CONSTRUCTION PLANS FOR CARRIAGE MEADOWS SOUTH AT LORSON RANCH

STREET, STORM SEWER, AND POND CONSTRUCTION PLANS

COVER SHEET
STREET, STORM SEWER AND POND
CONSTRUCTION PLANS

DATE: MARCH, 2017
 PROJECT NO. 100.030
 SHEET NUMBER C6.11
 TOTAL SHEETS: 37

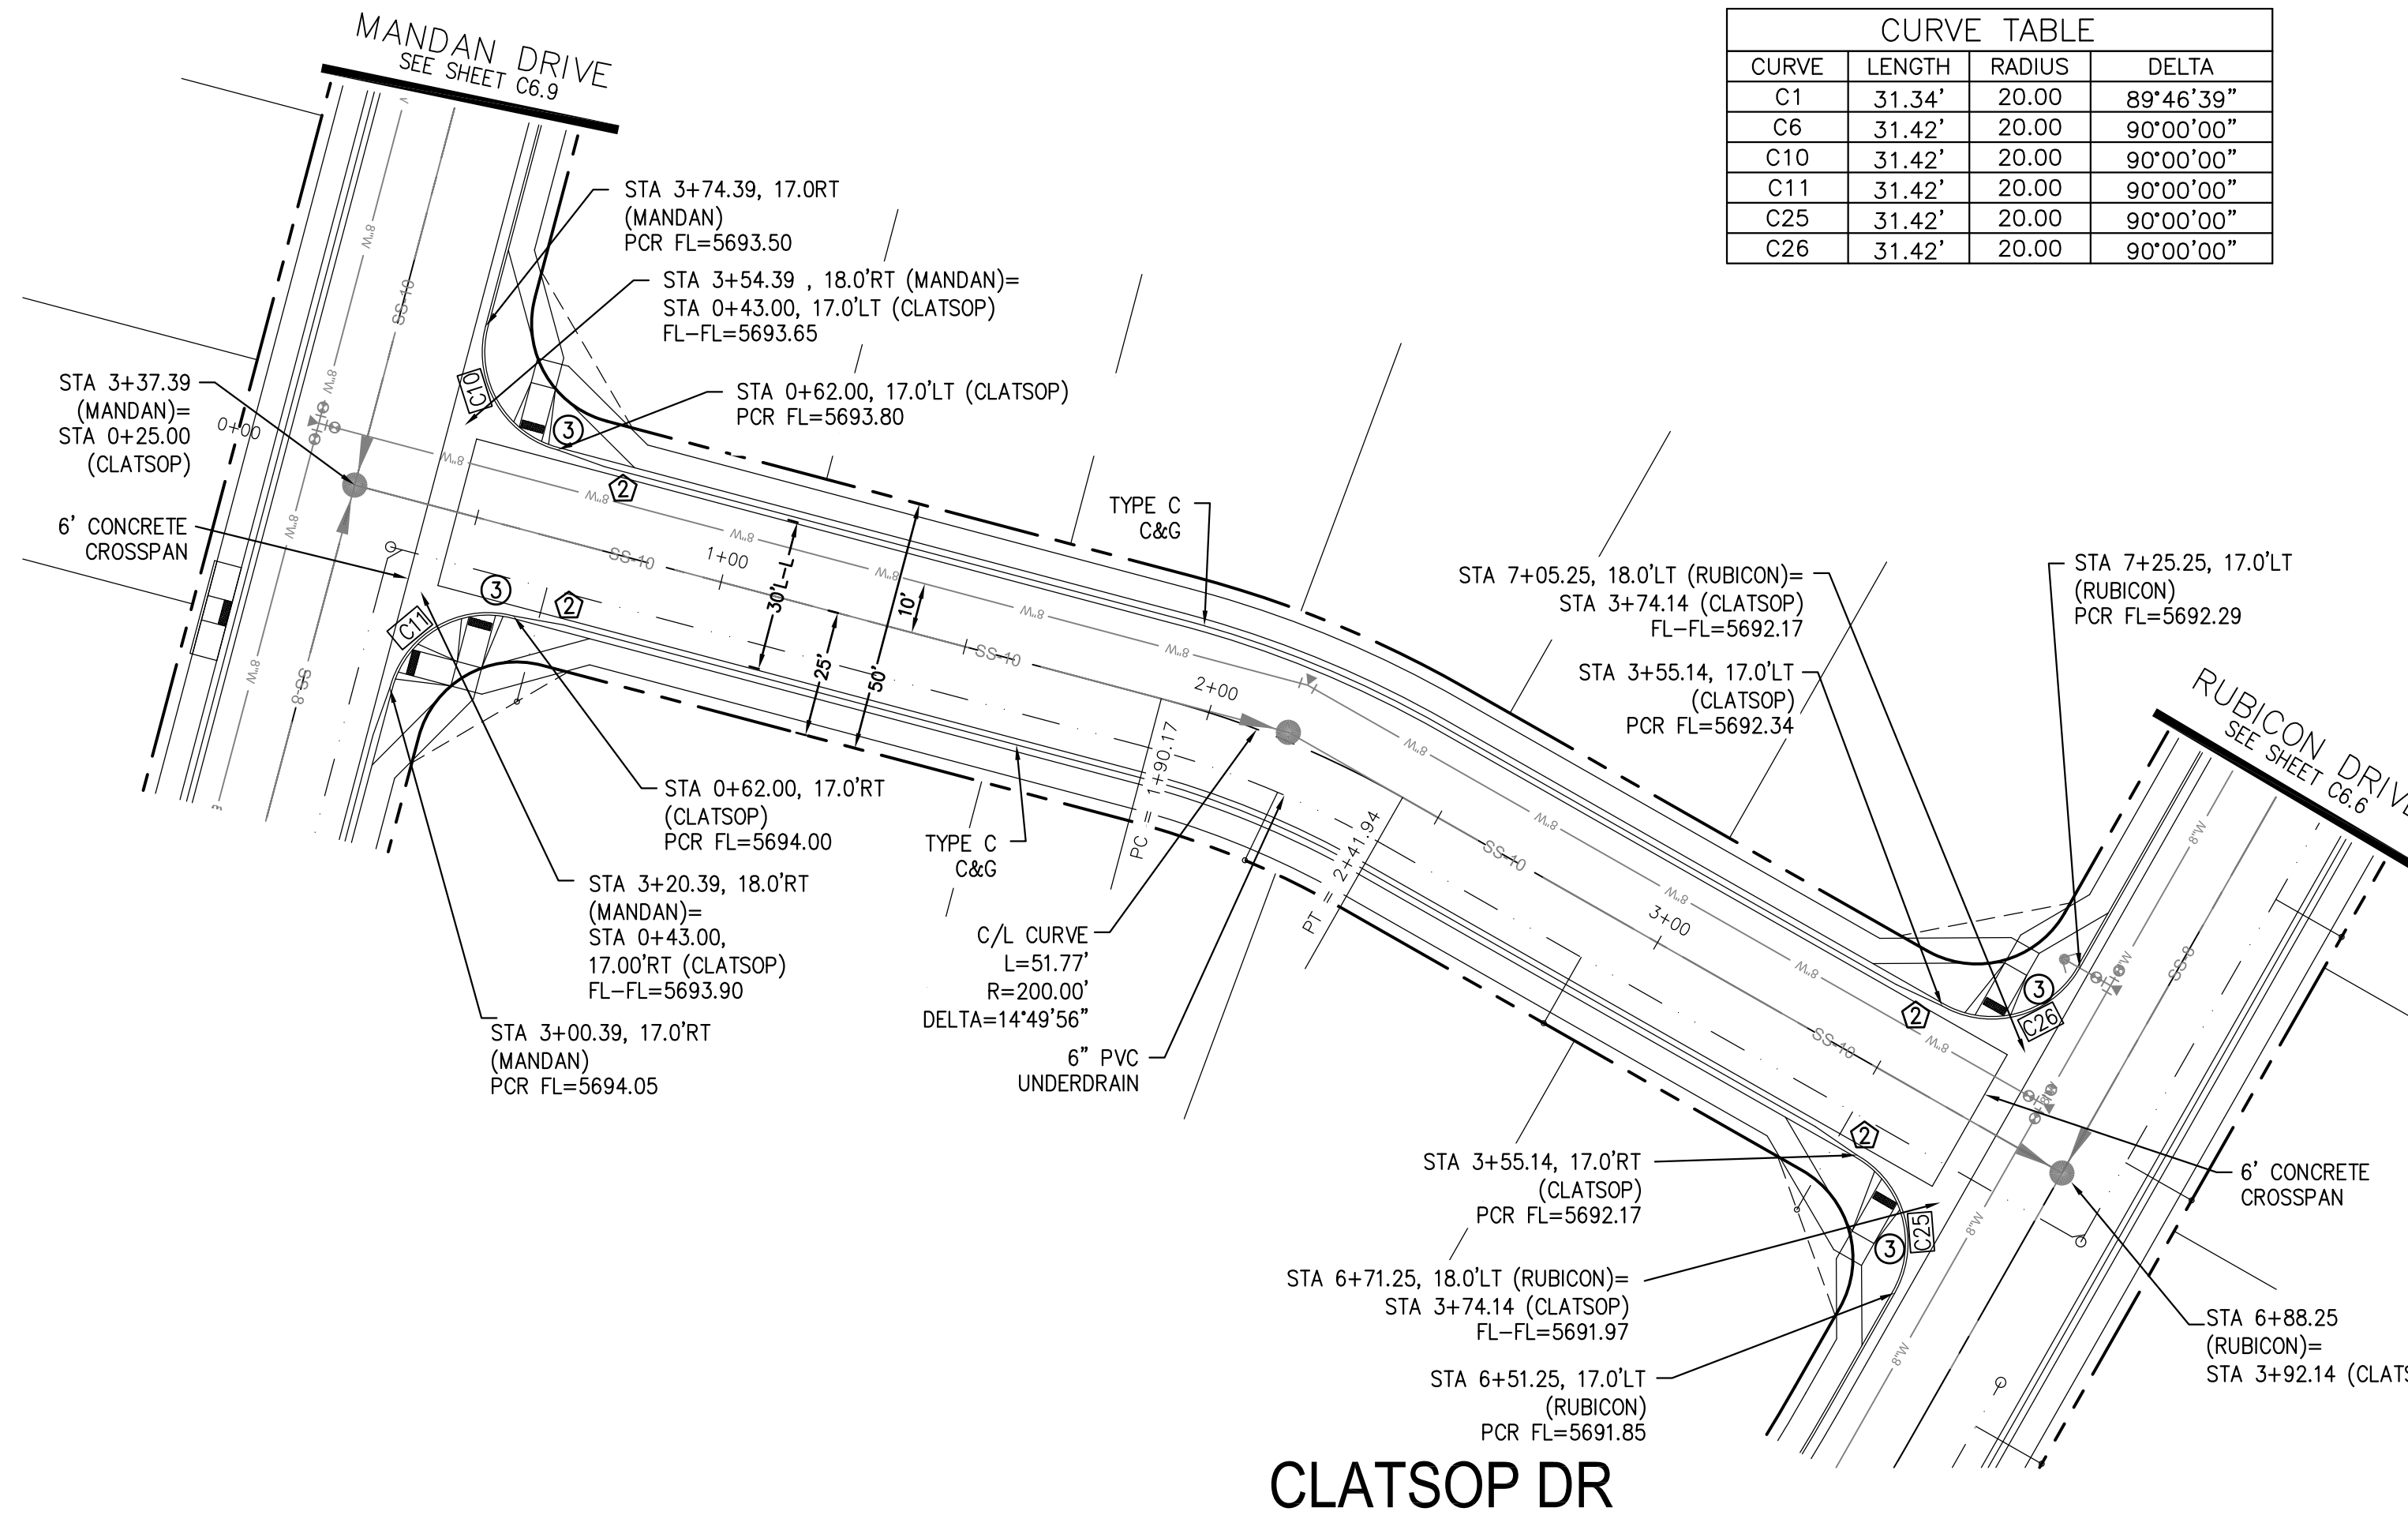
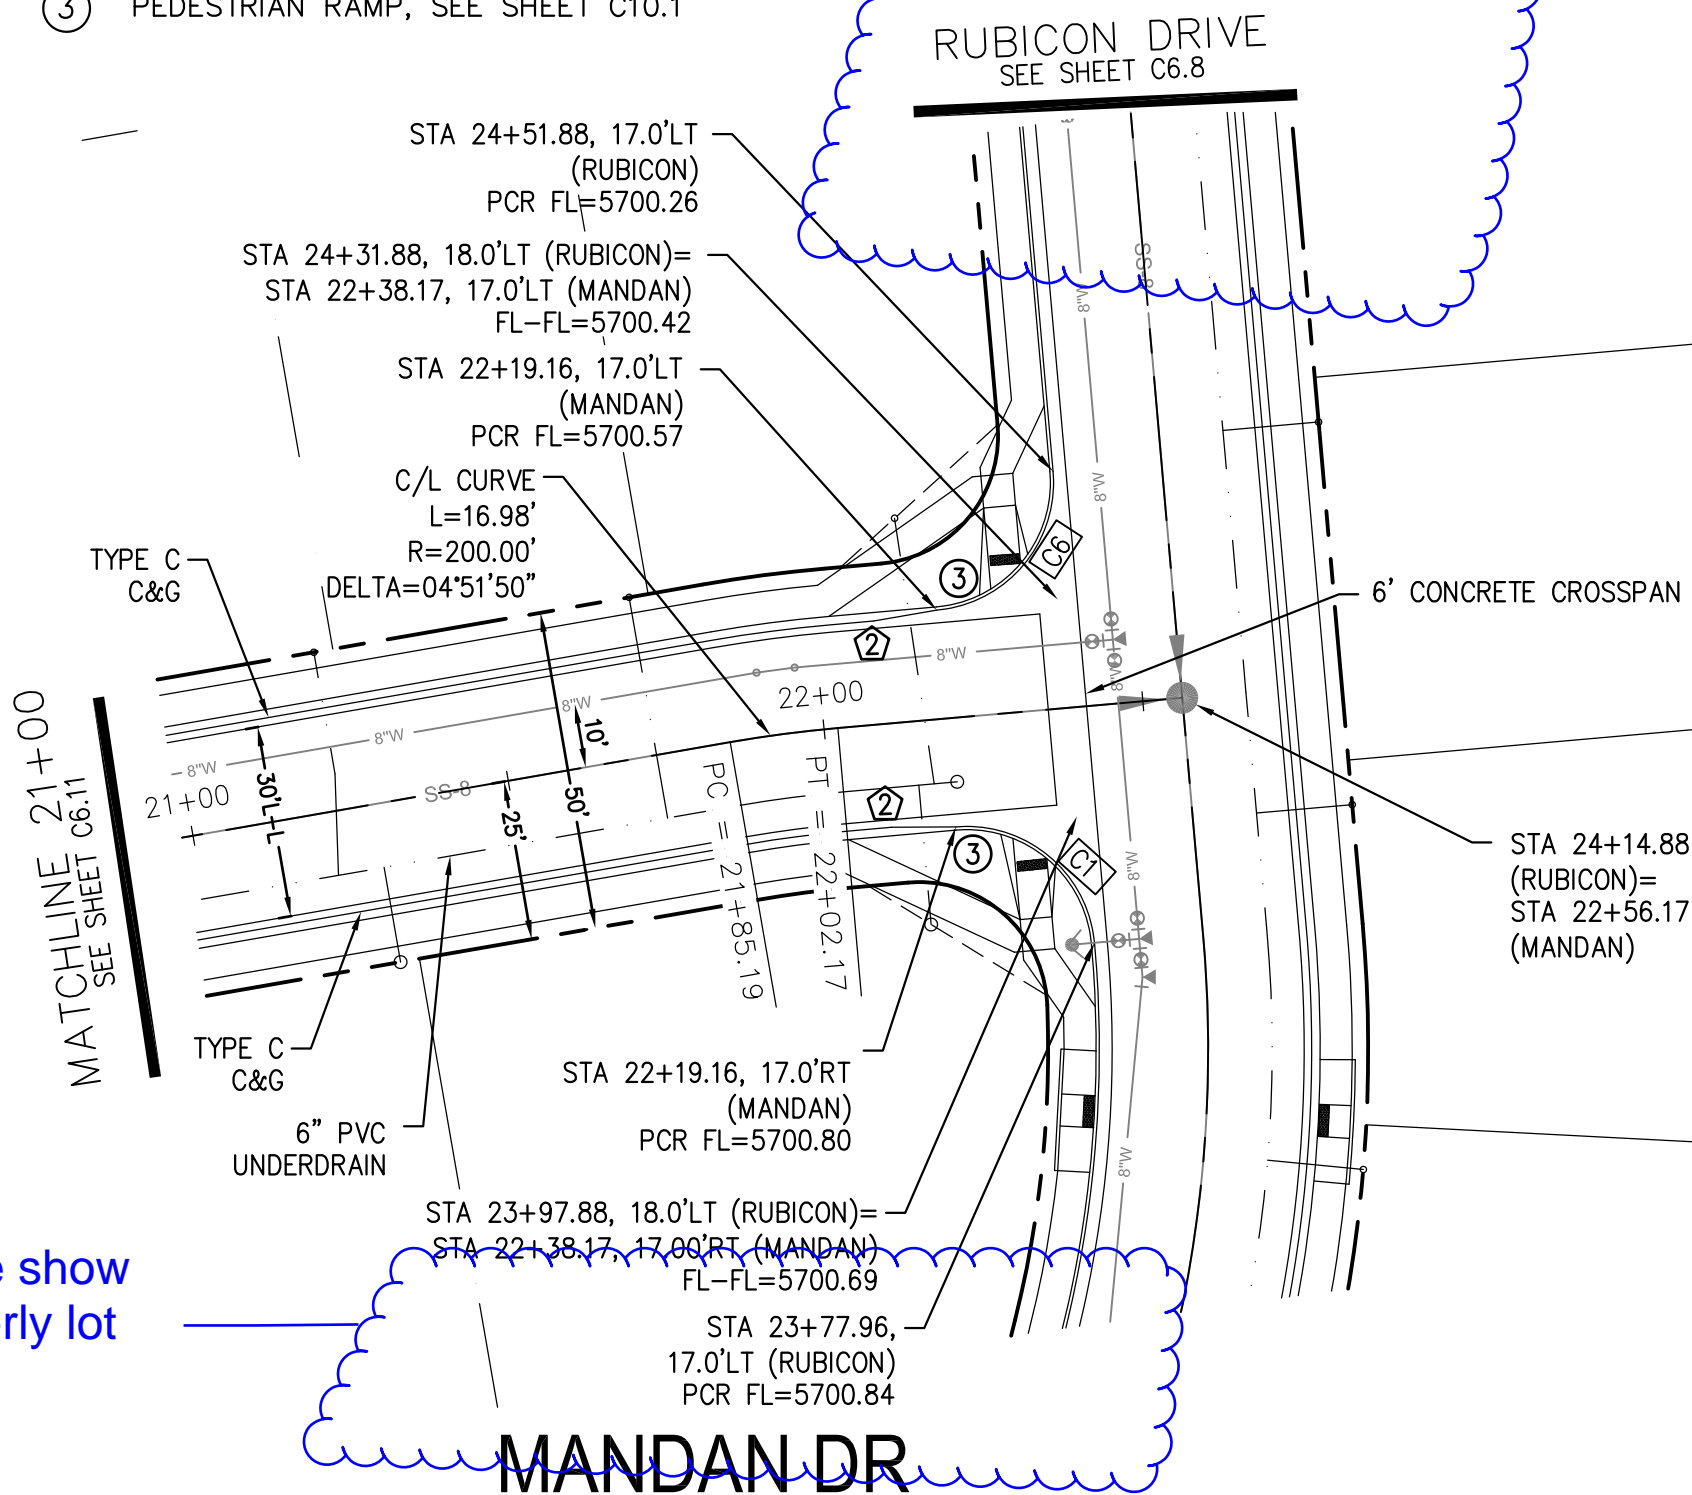
is this match line correct?
